WATERVIEW EAST COMMERCIAL CONSTRUCTION DOCUMENTS GENERAL NOTES	DESIGNED BY: ANF DRAWN BY: ANF CHECKED BY: JJM DATE: 04/21/2026		Kimley»Horn 2026 KIMLEY—HORN AND ASSOCIATES, INC. 2 North Nevada Avenue, Suite 900 Colorado Springs, Colorado 80903 (719) 453-0180		NO.	REVISION	BY	DATE	APPRO.
PRELIMINARY FOR REVIEW ONLY NOT FOR CONSTRUCTION Kimley»Horn Kimley-Horn and Associates, Inc.		PROJECT NO. 196195000		SHEET C0.1

WATERVIEW EAST COMMERCIAL
CONSTRUCTION DOCUMENTS
POND A DETAILS

WATERVIEW EAST COMMERCIAL
CONSTRUCTION DOCUMENTS
GEC INITIAL PLAN

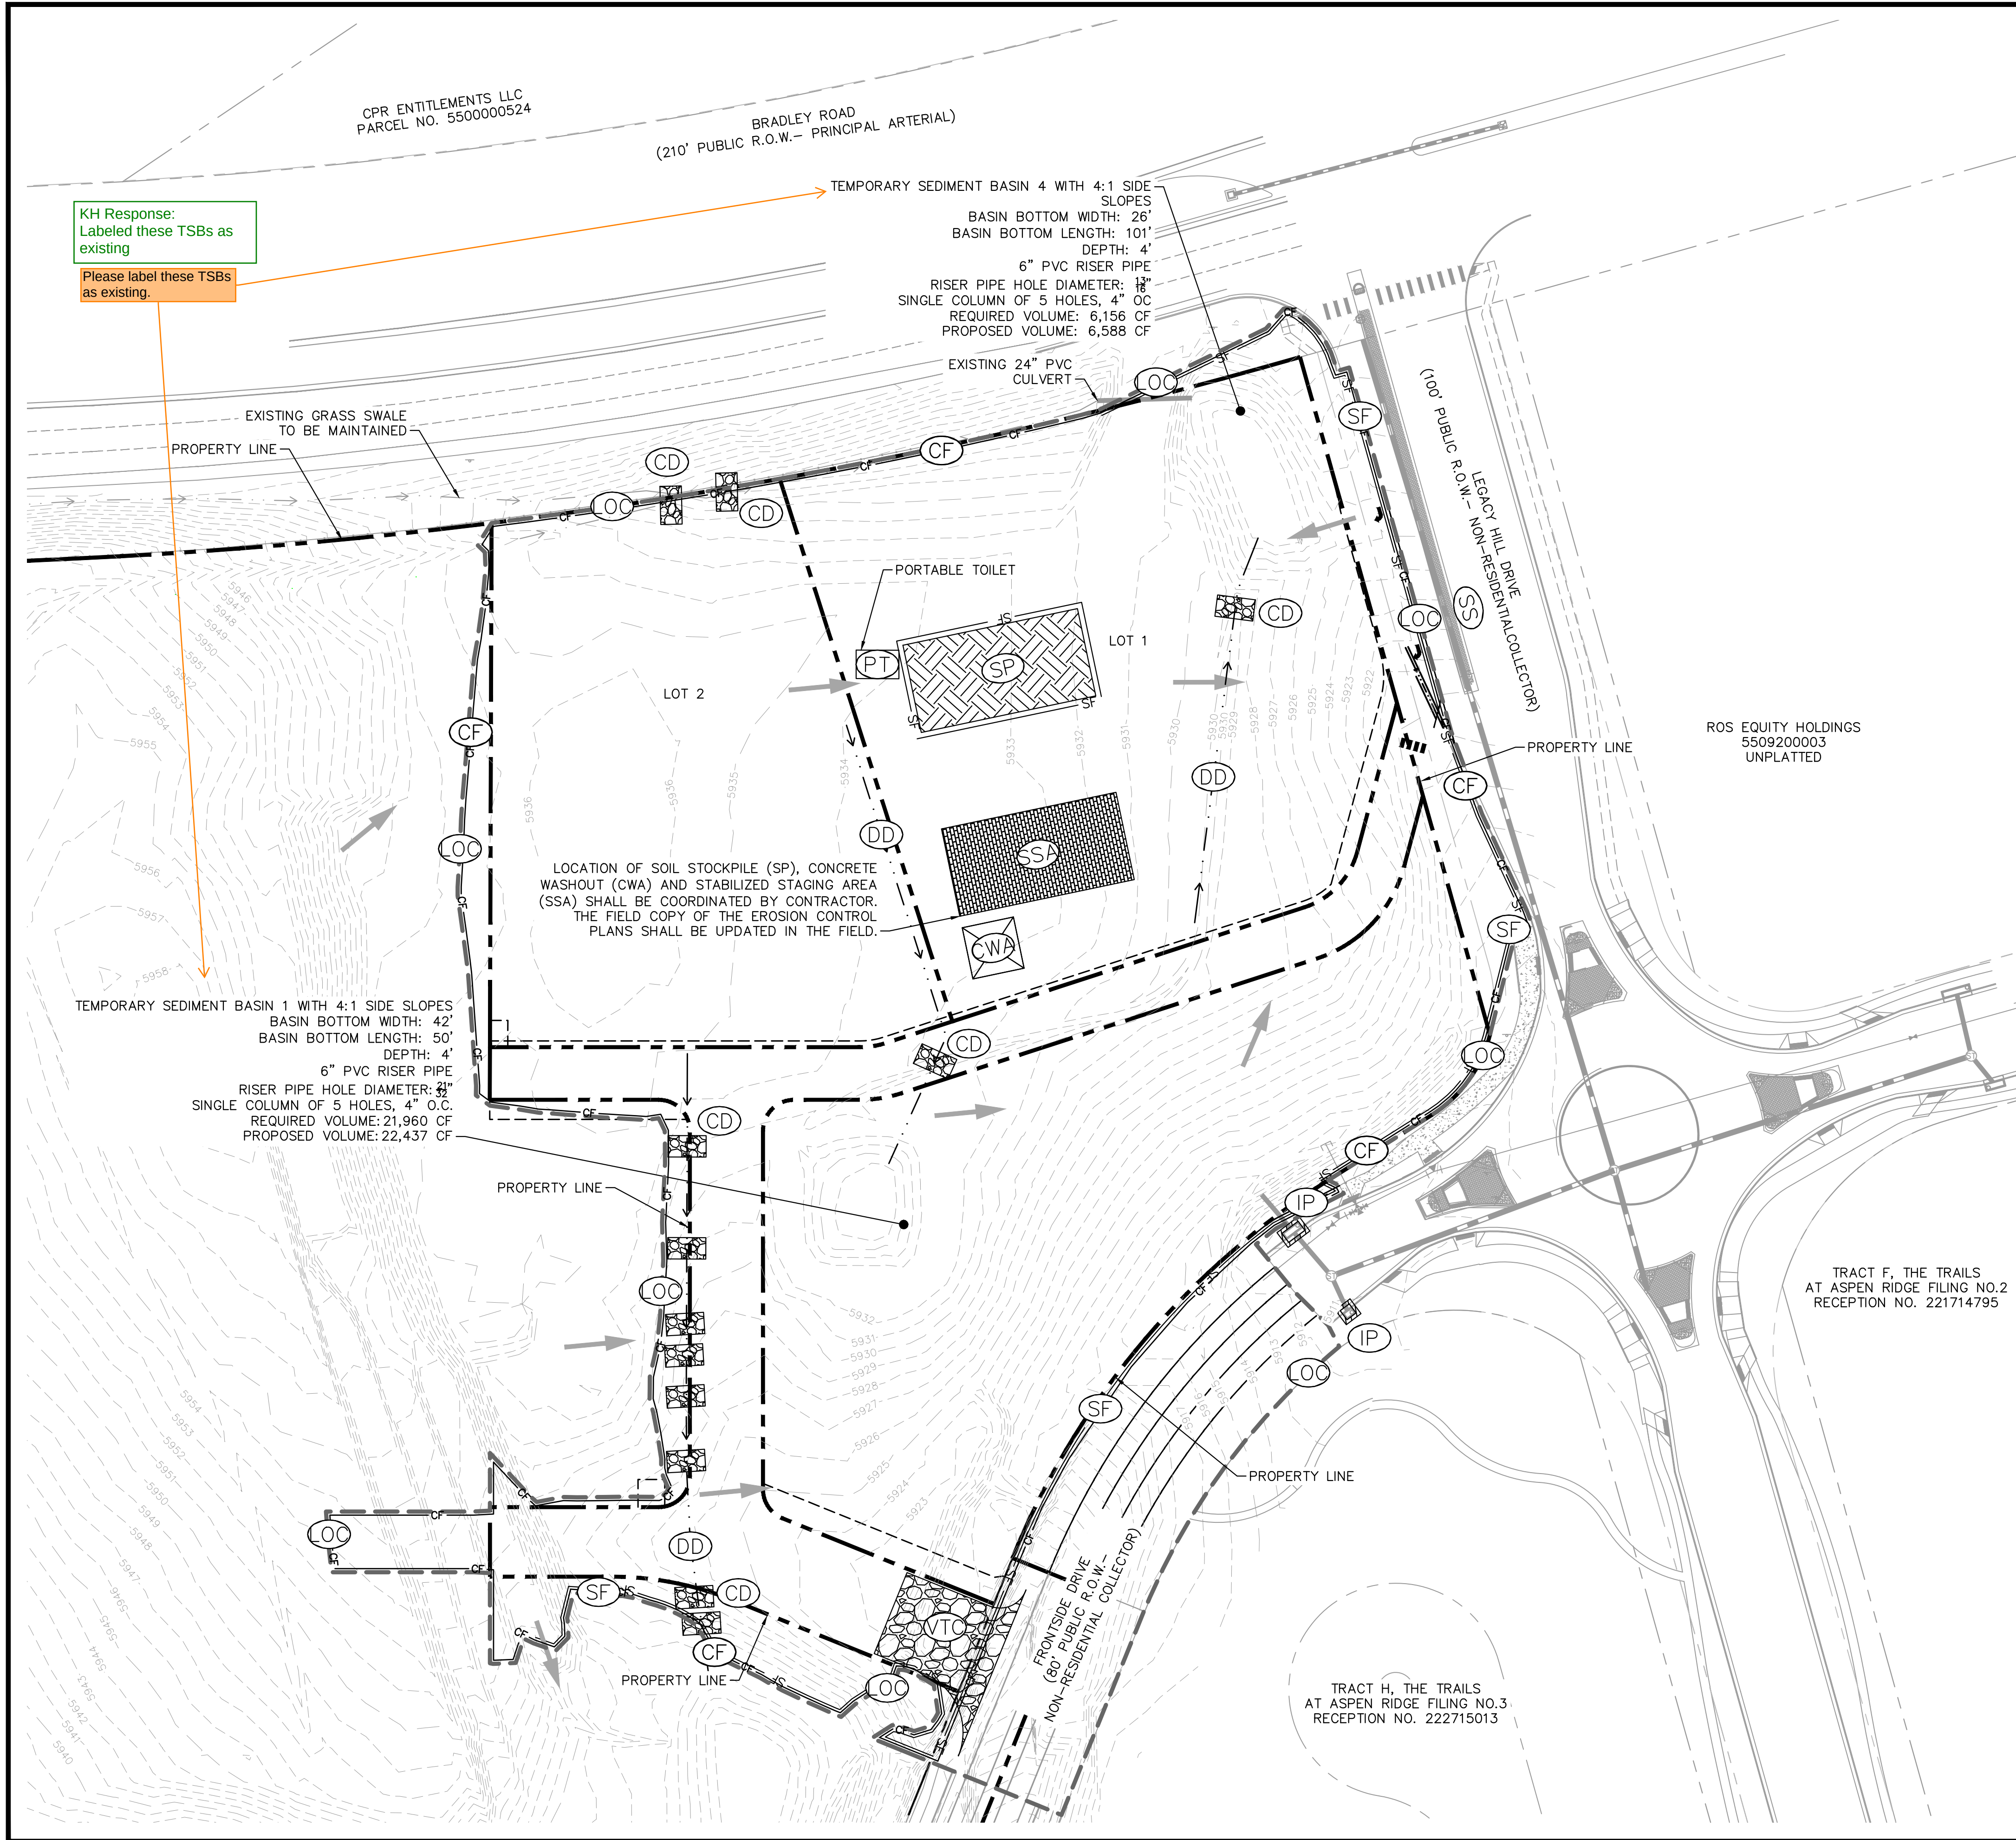
The top of the micropool
is Stage = 0ft, so since
most of the other
elevations shown on this
sheet are tied to that,
and you are incorrectly
calling Stage=0ft at the
trickle channel, all of
your elevations on this
sheet will need to be
revised.

clarify spacing between
bolts

Based on input gathered from industry experts, below is the
recommended gasket spec:
The gasket shall be made of 1/4-inch thick, 60 durometer EPDM
rubber in a continuous sheet the size of the orifice plate. The
sheet shall be placed between the orifice plate and the concrete
wall, with the width of the overlap between the plate and the
concrete. Openings shall be cut into the sheet corresponding to
the plate bolt holes and the concrete wall opening, cuts made
either by the contractor in the field or by the manufacturer. Or
equivalent gasket approved by EPC. Note that caulk is not an
approved equivalent and will not be accepted by EPC.

Detail 5 on the left
shows it varying from
4.1ft to 6ft.

Provide access road
detail/cross section,
including stone sizing
and gradation. Show
cross slope at 2%.

KH Response:
Elevations are at the
centroid and Dimensions
have been made clearer.

KH Response:
Updated callout to reference section A & B
details on this sheet. See section A & B for
spacing details.

KH Response: Note has been
added.

KH Response:
This has been
corrected to say it
varies from 4.1' to 6'

KH Response:
Access road detail provided

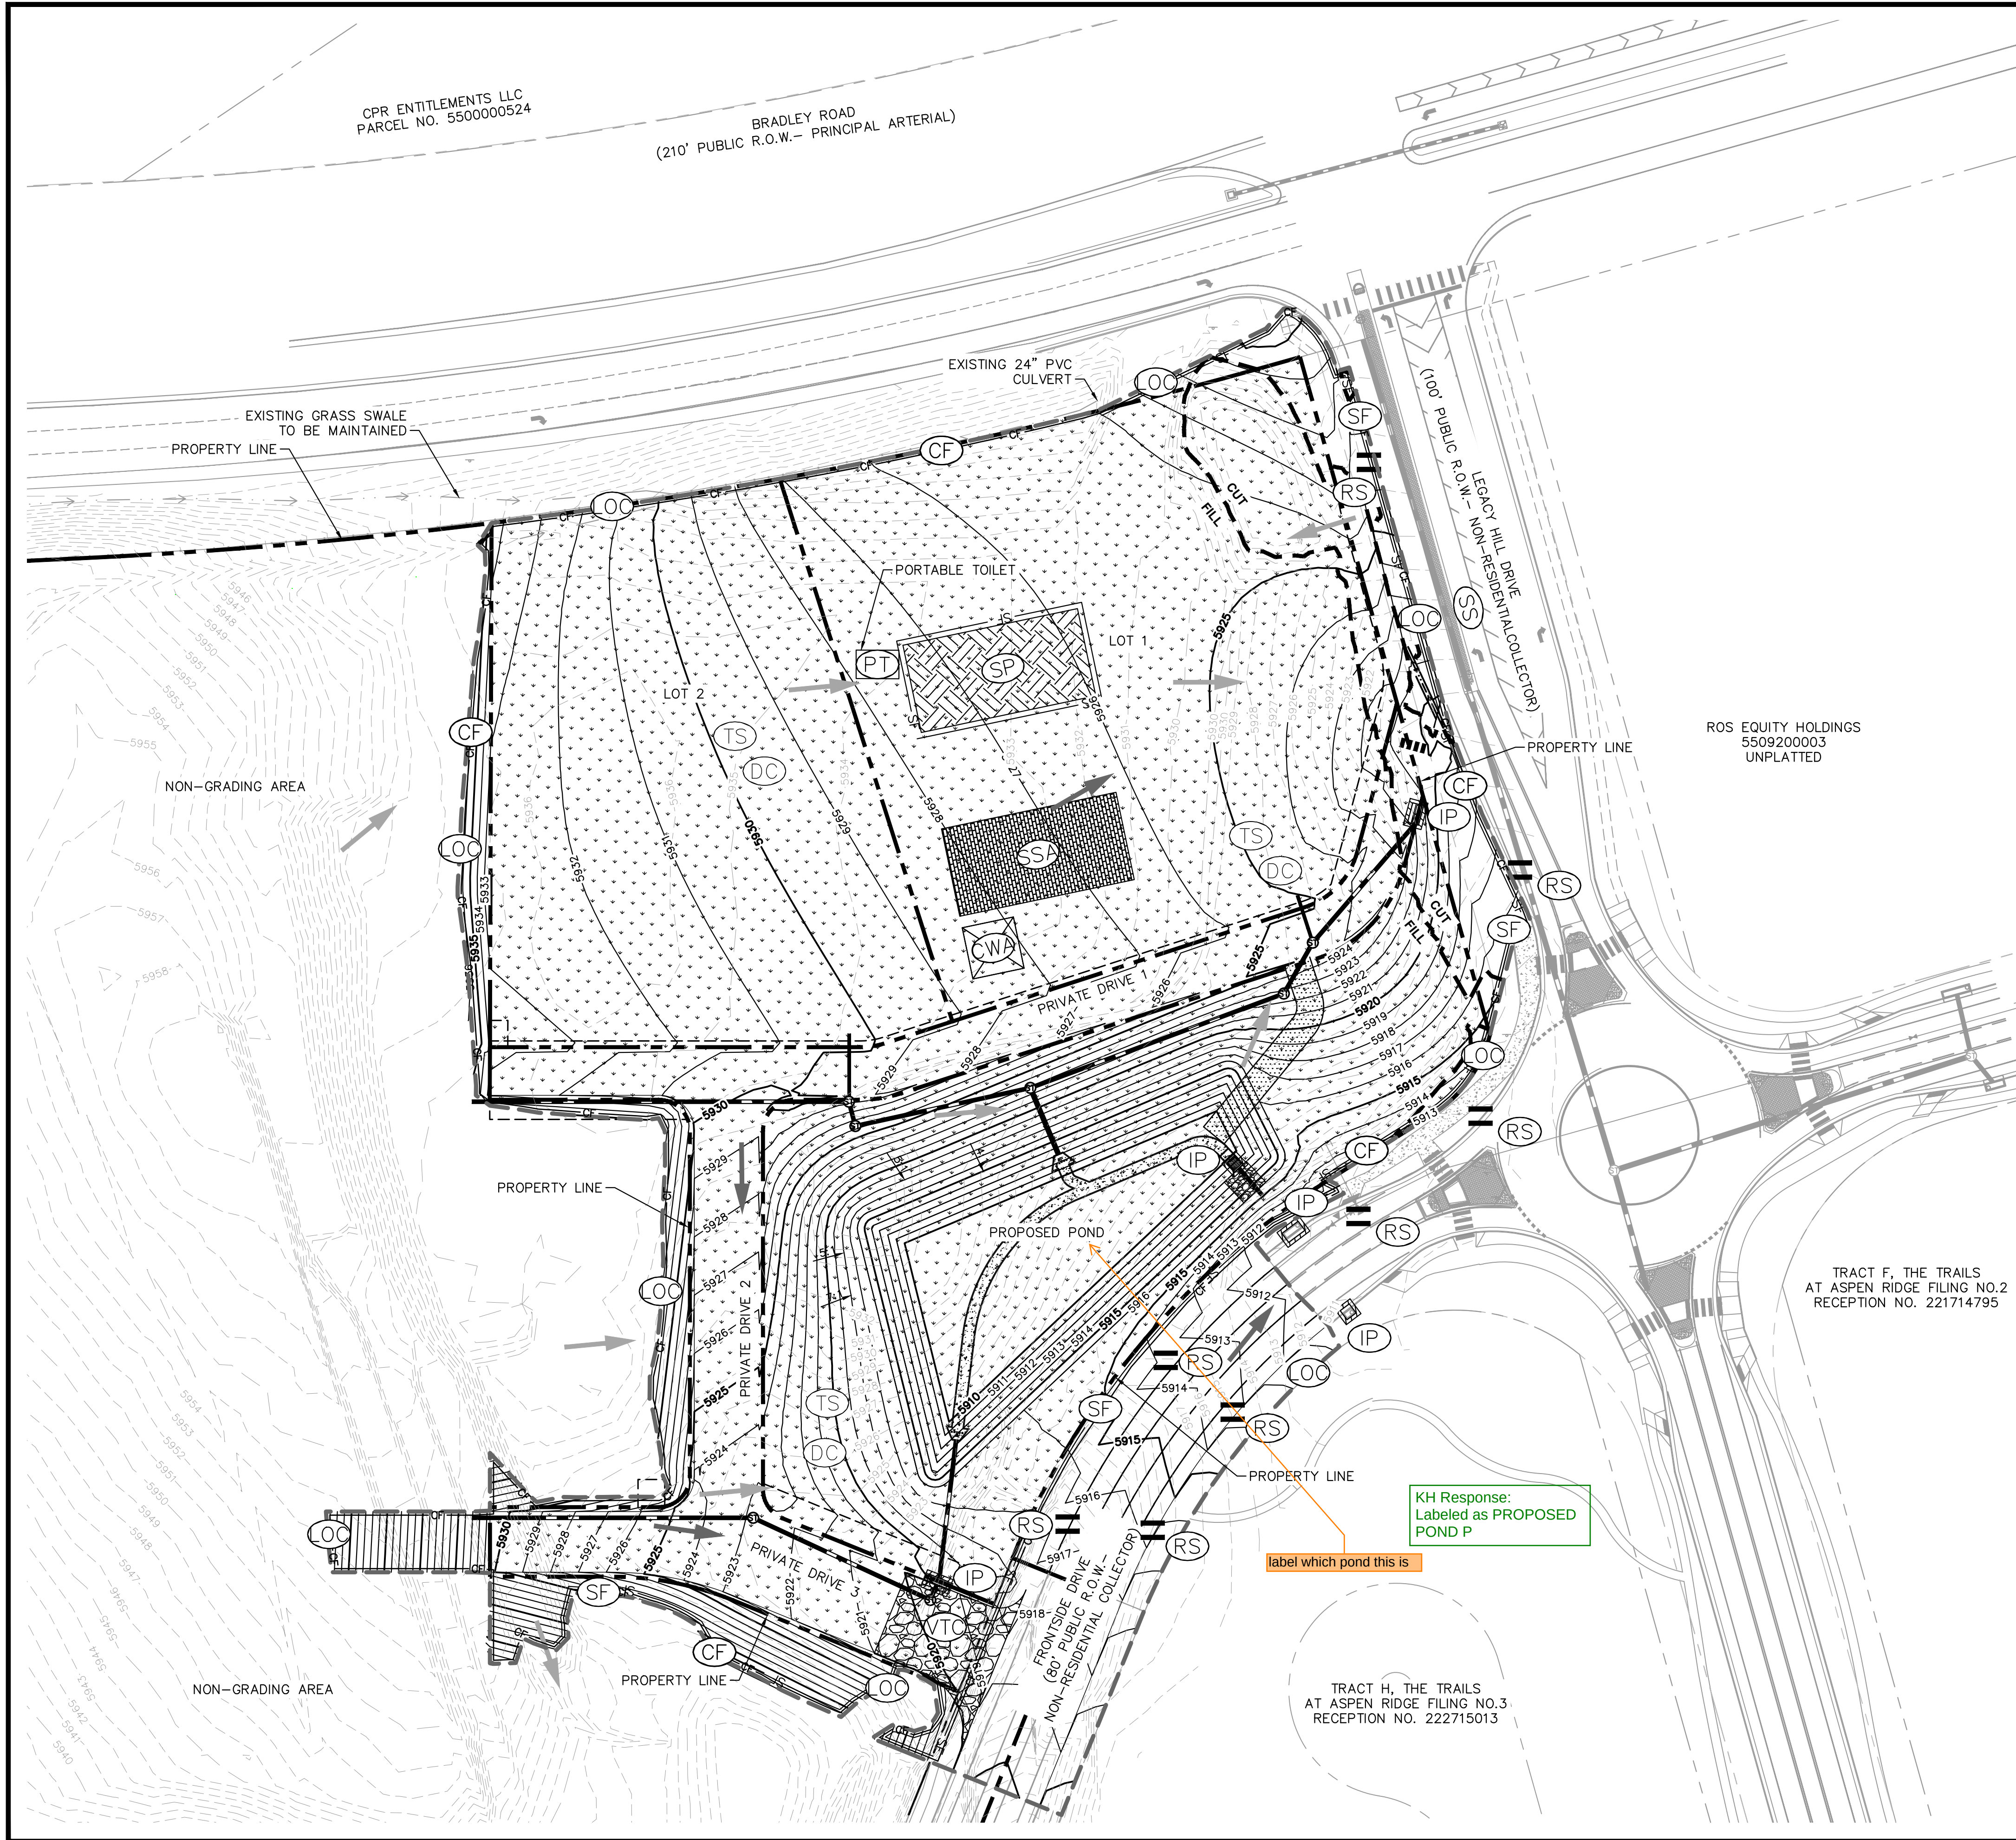
Add a general note: all areas to be vegetated with seeding should also be temporarily stabilized via surface roughening or some other means.

KH Response:
Added as a general note
